UNITED STATES PATENT AND TRADEMARK OFFICE

Office Action Summary

10/524,385

OH ET AL.

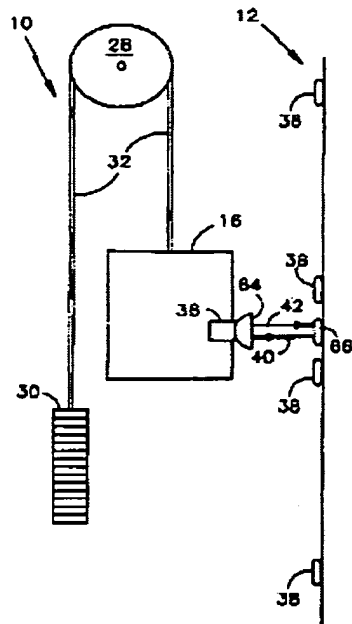
1. The drawings are objected to because the blank rectangular boxes and/or merely numbered boxes of figure 1 must be labeled. Conventional features disclosed in the description and claims, where their detailed illustration is not essential for a proper understanding of the invention, should be illustrated in the form of a graphical drawing symbol or a labeled representation (e.g., a labeled rectangular box). see 37 CFR 1.83(a). It is further pointed out that merely numbering the boxes is not considered an appropriate label. Structural elements which can be understood by conventional graphical drawing elements are not required to be labeled. Electronic elements enclosed in a "black box" require consulting the text of the specification and thus require labeling. If the box is too small to label, an appropriate label with an arrow pointing towards the box is acceptable. Correction is required.
